Letter of Transmittal

Reference: Care'n Cleaners Updated Information – Care'n Cleaners, 735 West Main Street, Waupun, WI (BRRTS #02-14-552053)

Figure No. **1**
 Title **Site Layout**

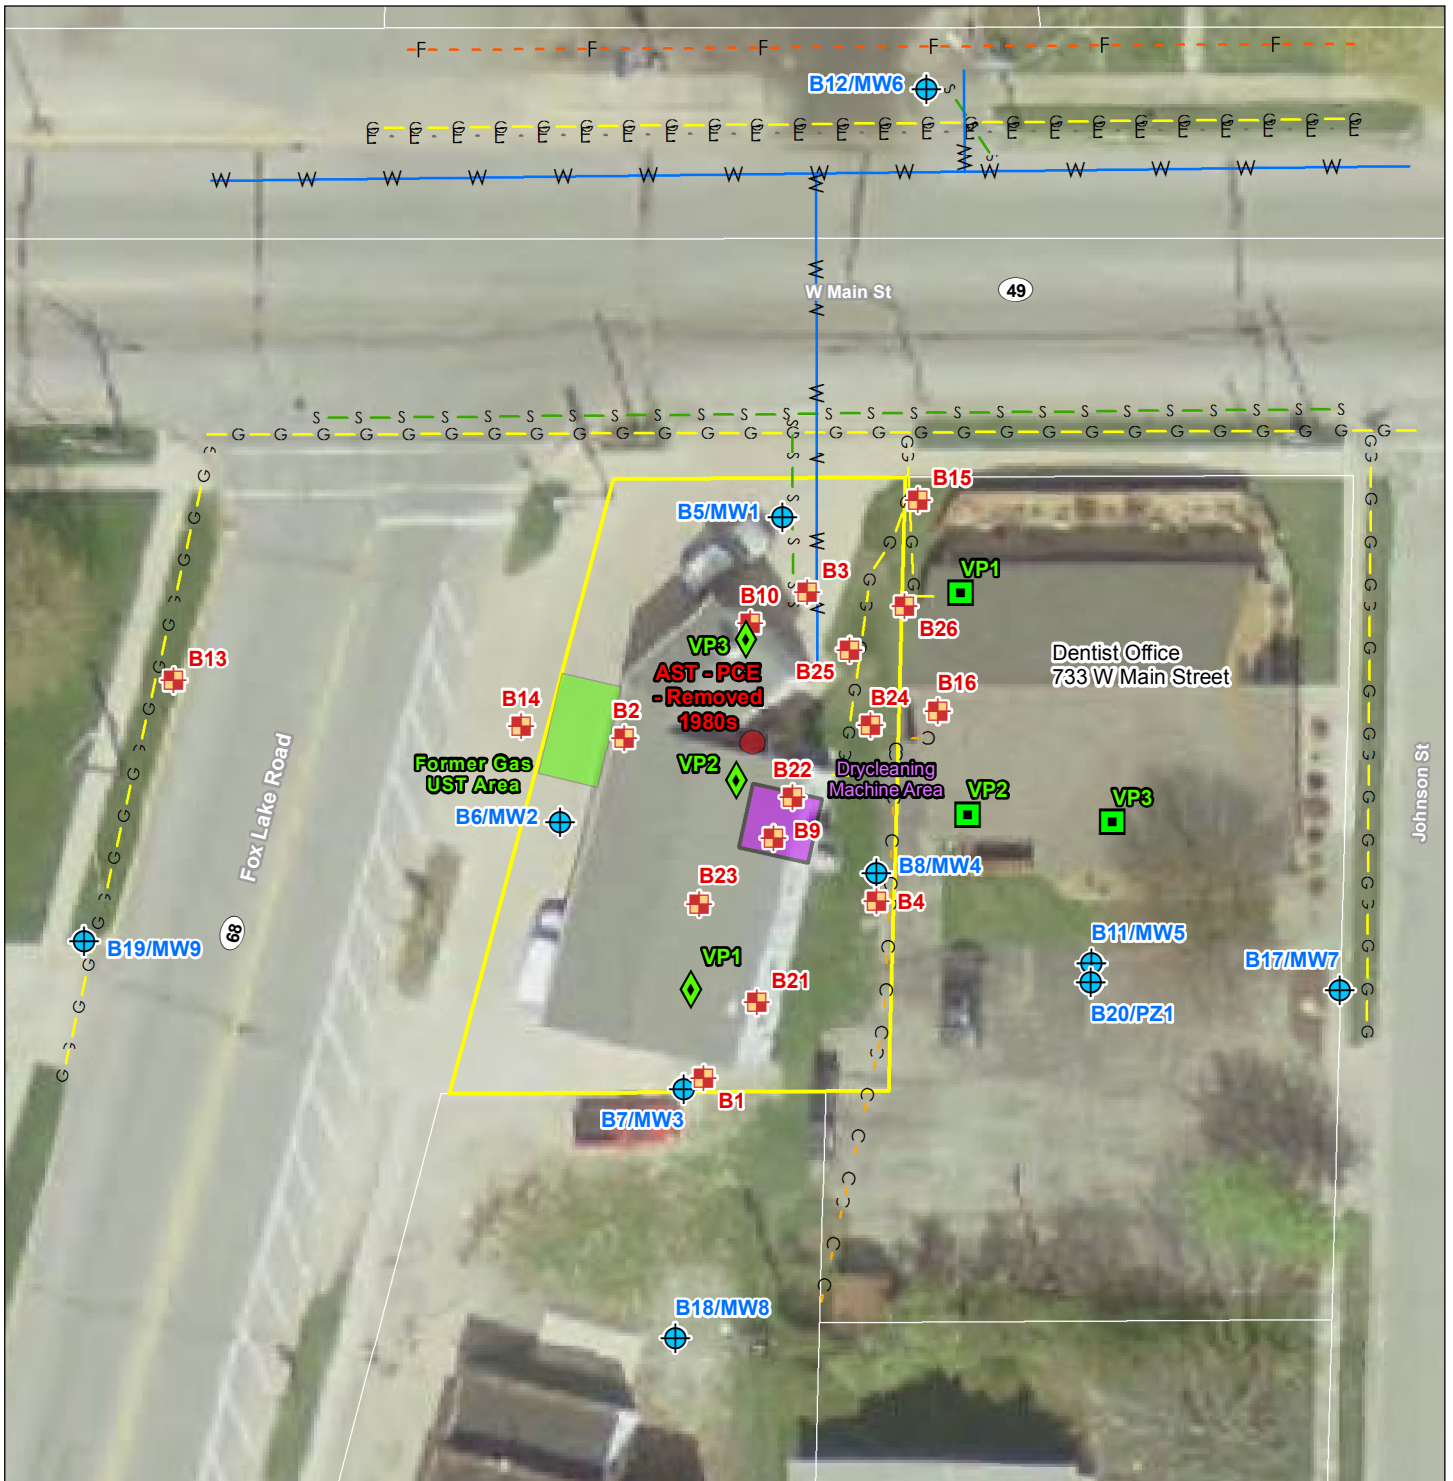
1. Figure 1 – revised site layout map. We used the best and most recent aerial photograph we had available. The photograph is taken at an angle, so there is still some distortion, but locations of all boreholes, utilities, etc. have been confirmed. Former AST/UST/drycleaning machine location have been added.
2. Figure 2 – revised map of PCE in soil. We revised the map to reflect mix up in soil sample data.
3. Table 1 – revised/corrected the table per your comments.
4. Table 2 – no changes, but provided for your records
